UNITED STATES PATENT AND TRADEMARK OFFICE

APPLICATION NO.	FILING DATE	FIRST NAMED INVENTOR	ATTORNEY DOCKET NO.	CONFIRMATION NO.
10/616,534	07/09/2003	Koay H. an Tatt	70021020-1	1966

Office Action Summary	Application No. 10/616,534	Applicant(s) AK AN TATT ET AL.	
	Examiner Leonardo Andújar	Art Unit 2826

DETAILED ACTION

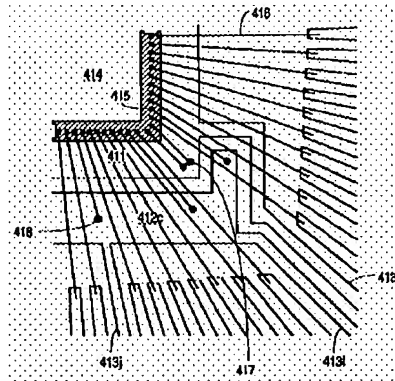
Fan does not show that the power lead 340 comprises a power ring having a conductor disposed between the leads and the die pad. Templeton (e.g. fig. 4D) shows a package including a power ring 412 having a conductor disposed between the leads 413 and the die pad 411 wherein at least one power connection 415 of the die is connected to the power ring.

The provision of a ring in leadframes according to Templeton's disclosure allows greater flexibility in placement of ground and/or power circuit elements and bond pads on the semiconductor die. Generally, in order to minimize the length of the ground and/or power current paths (thereby minimizing inductance and, thus, noise) on an integrated circuit, it is desirable to locate ground and/or power circuit elements and bond pads on the semiconductor die in proximity to the ground and/or power lead or leads. This type of lead frame configuration results in closer placement of ground and power planes to the die than has previously been the case. Consequently, shorter bond wires are needed to make connection between bond pads on the die and the power plane. Since bond wires are a primary source of inductance because of their relative thinness, the shortening of these bond wires significantly reduces the inductance in the power and ground current paths (col. 7/lls. 2-38).

It would have been obvious to one of ordinary skill in the art at the time the invention was made to dispose a power ring comprising a conductor between the die pad and the leads disclosed by Fan in order to reduce the inductance in the power paths because this configuration permits the use of shorter bond wires because the power plane can be located closer to the die pad as taught by Templeton.
